State of Utah  
DEPARTMENT OF NATURAL RESOURCES  
DIVISION OF OIL, GAS AND MINING

TO: Minerals File  
FROM: Paul Baker, Reclamation Biologist *PBB*  
RE: Site Inspection, ECDC Environmental, LC, ECDC Clay Mine, M/015/062, Emery County, Utah

Date of Inspection: September 6, 2001  
Time of Inspection: 5:00 to 6:00 p.m.  
Participants: Tony Gallegos and Paul Baker, DOGM

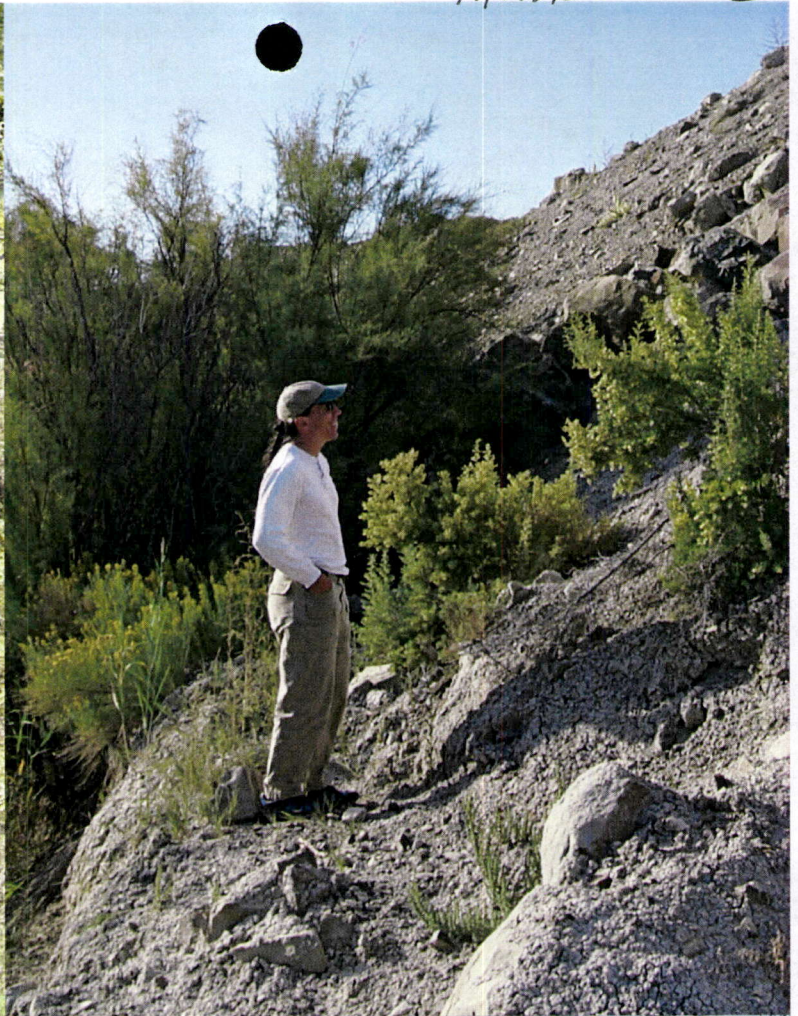
Photos of the site are attached to this report. The photos labeled 2 and 7 are overviews of the area. In photo 2, the pile in the center left is the area presumed to be a spoil or waste pile. In the foreground is an area with a low or non-existent berm. Photos 1, 3, 5, and 8 show where we found remnants of a straw bale dike. The other pictures are intended to show the proximity of the disturbance to the Price River.

The site needs to be modified to match Exhibit VI in the plan. The spoil pile needs to be pulled back to allow room for an earthen berm 25 feet away from the river. Fill material placed near the river to the southeast of the pile also needs to be pulled back and a berm constructed to keep drainage from the mine from going into the river.

Plan View

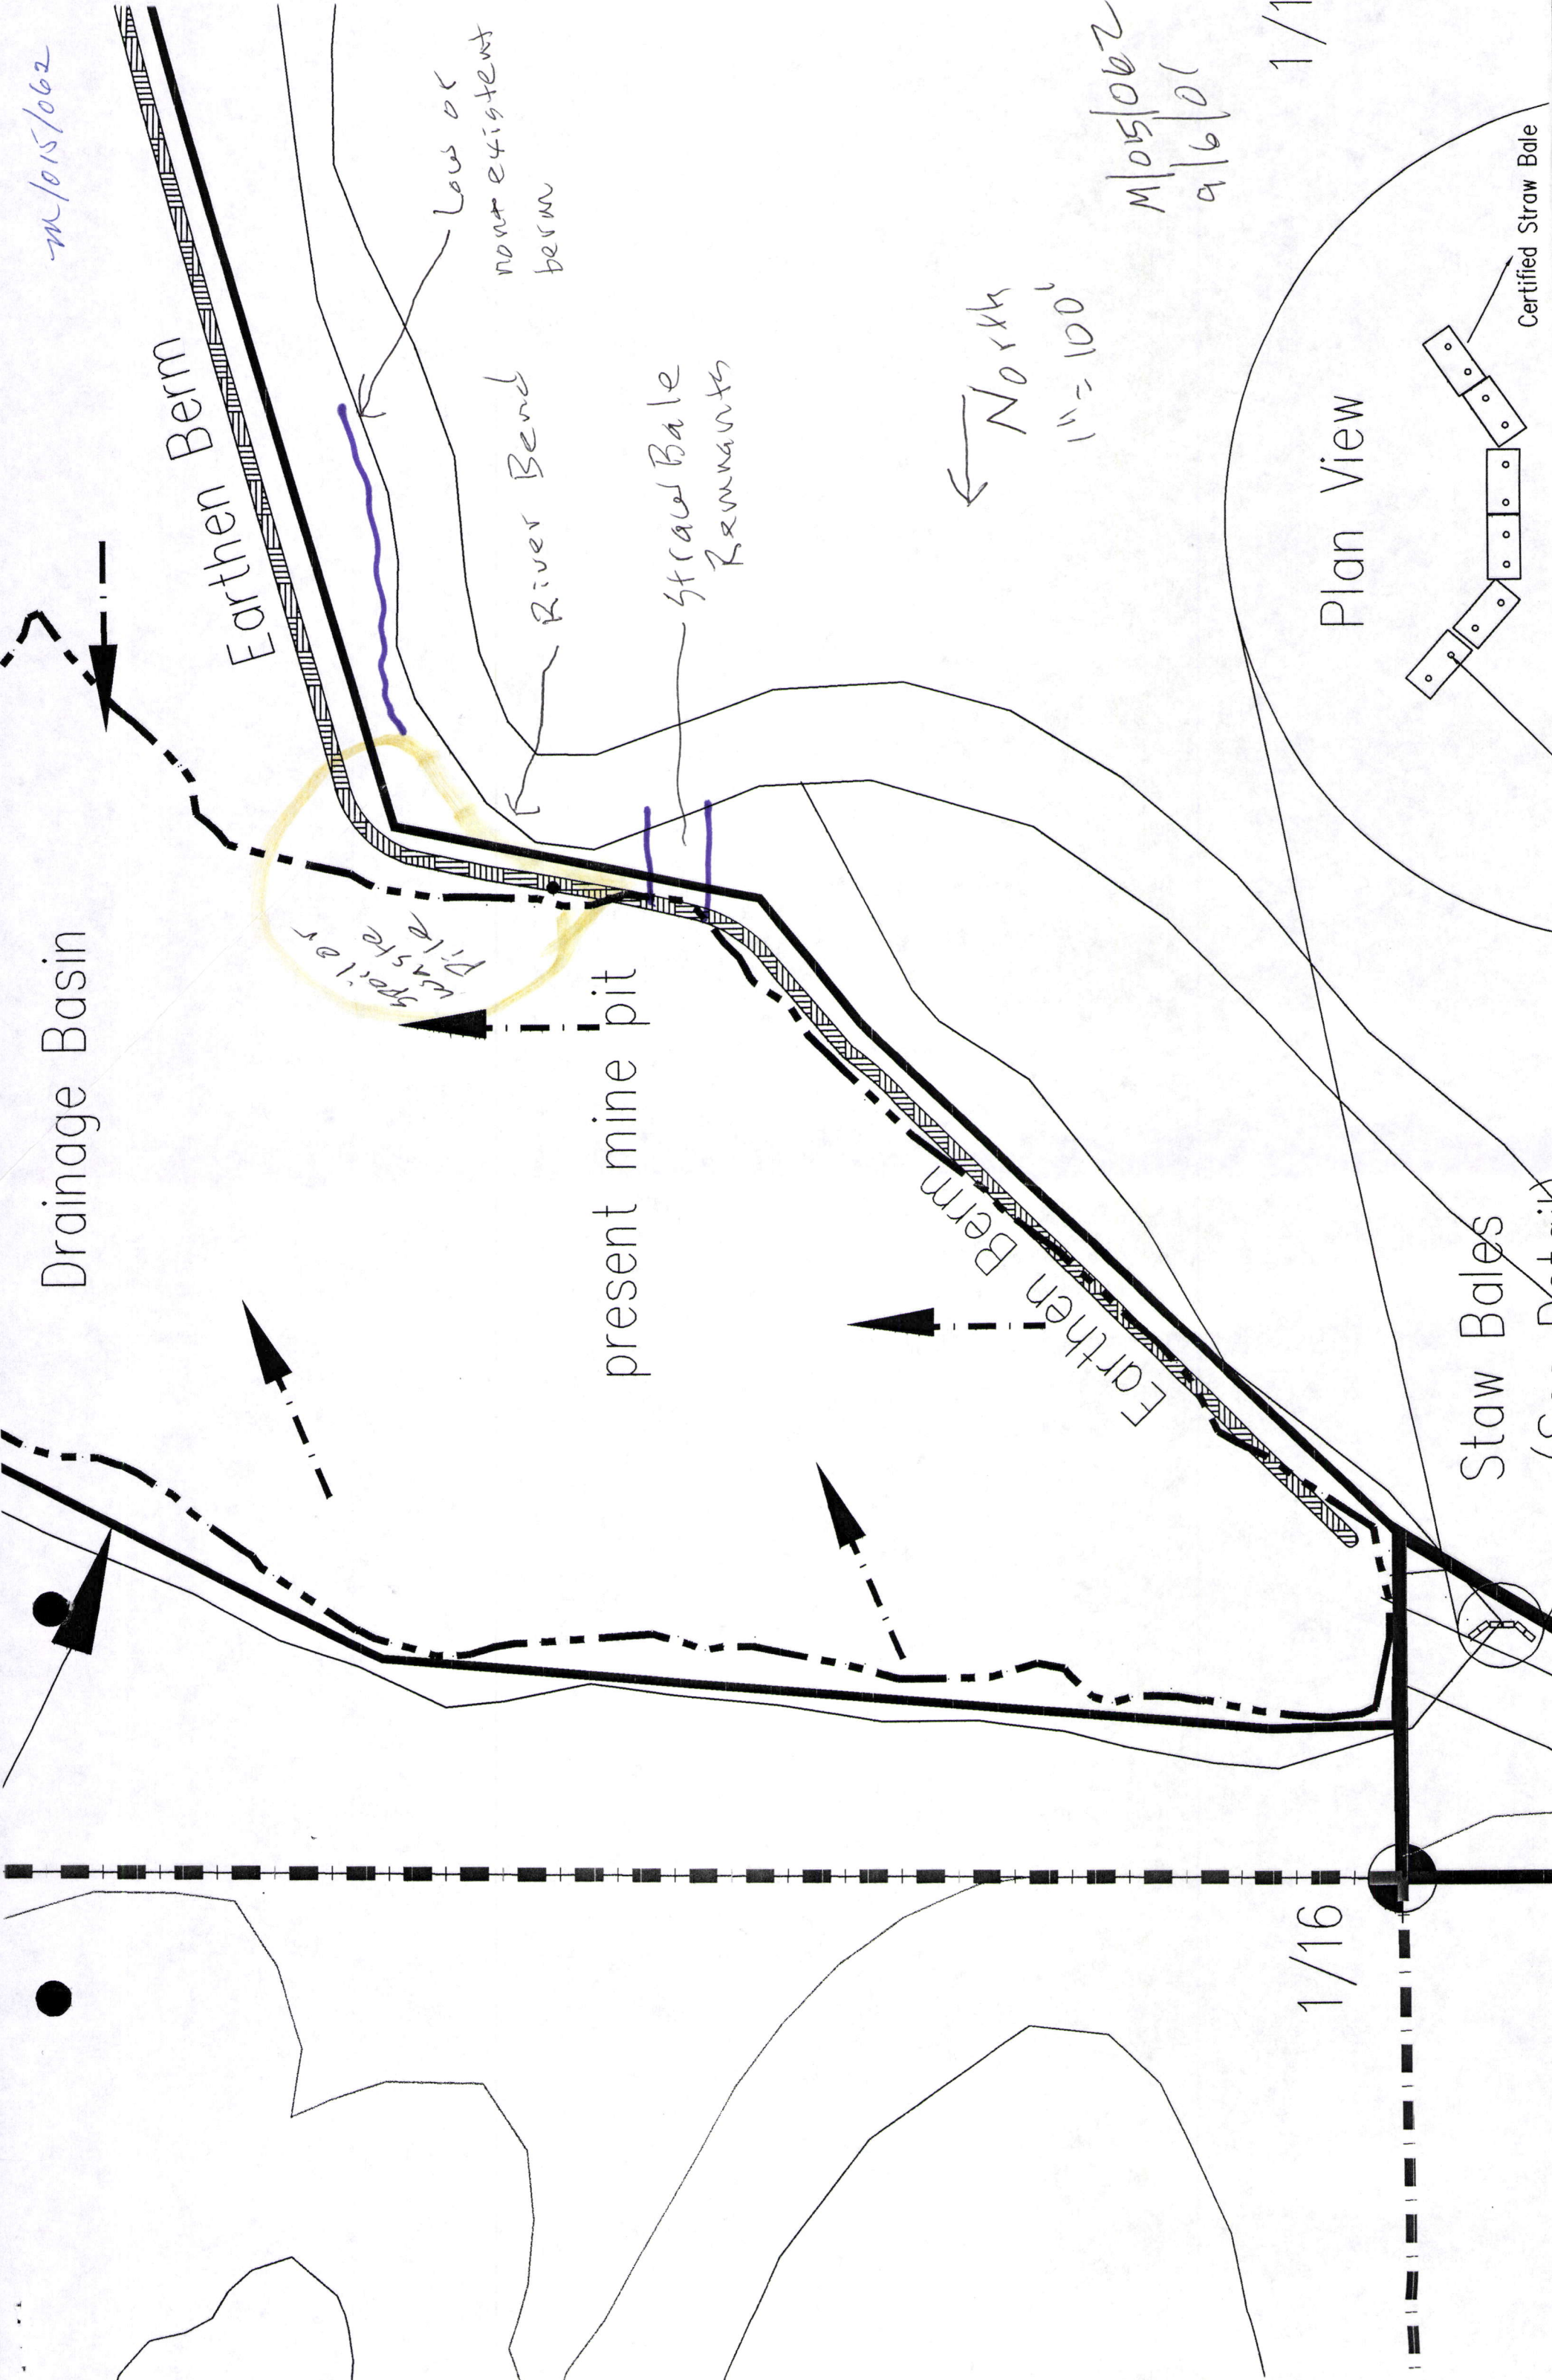
Exhibit VI of the operation plan in the file, dated March 15, 2000, shows an earthen berm along the Price River from the haul road to the end of the disturbance. According to this map, there is a sharp bend in the Price River where the berm is within 25 feet of the river, but otherwise, the berm should be no less than about 50 feet from the river. (See the attached copy of the map from the plan.)

The mining disturbance has been extended to the south somewhat compared to the disturbance shown in Exhibit VI. It appears to still be in the designated disturbed area.

The earthen berm we found extends from near the bend in the river toward the northwest. From the bend toward the southeast, there is either no berm or only a short one that would be ineffective. The disturbance extends to within one or two feet of the bank of the Price
